Appl. No. 10/731,496
Amdt. dated August 22, 2006
Reply to Office action of May 23, 2006

AMENDMENT TO THE DRAWINGS

REMARKS / ARGUMENTS

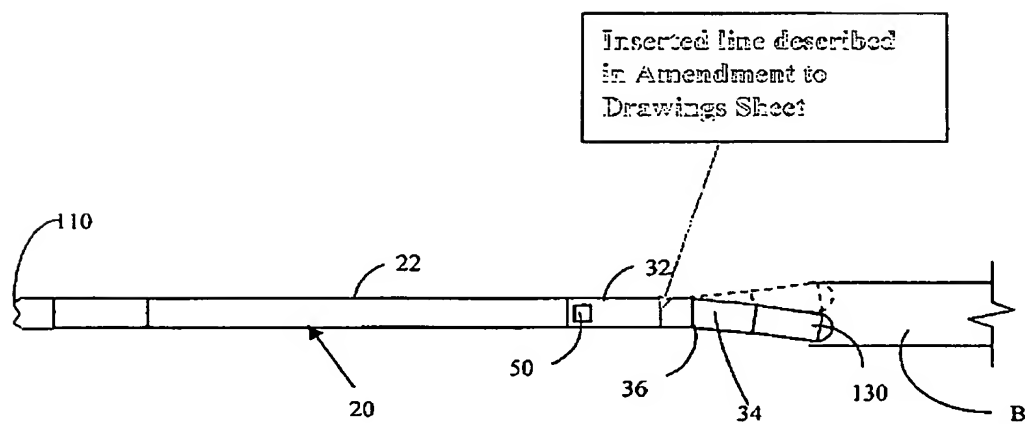
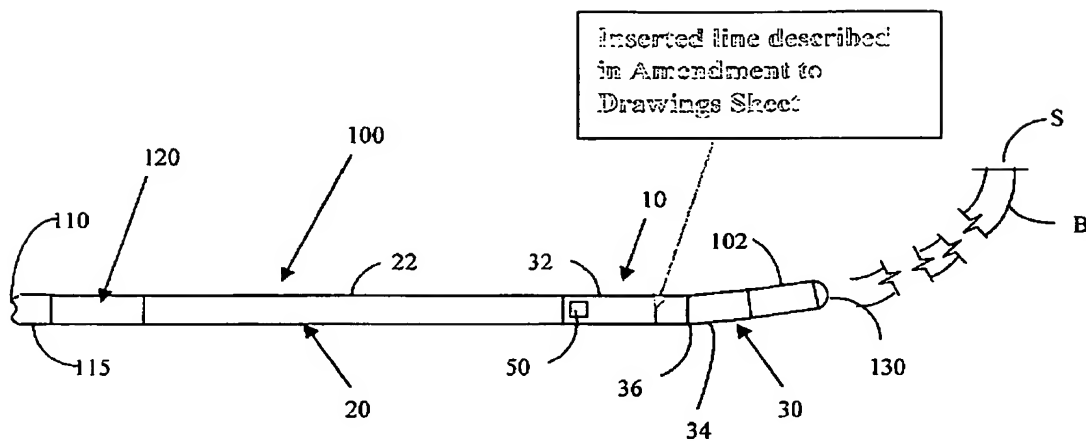
- Fig 2
 - Line was missing in drawing adjacent to Item 36. Line has been inserted so as to
 - clearly identify the division between Items 32 and 34
- Fig 3.
 - Line as missing in drawing adjacent to Item 36. Line has been inserted so as to
 - clearly identify the division between Items 32 and 34
- Fig 4.
 - Numerical call out for Item 24 was moved to provide clarity
 - Item 32 was identifying the wrong item and has been corrected to illustrate the appropriate component
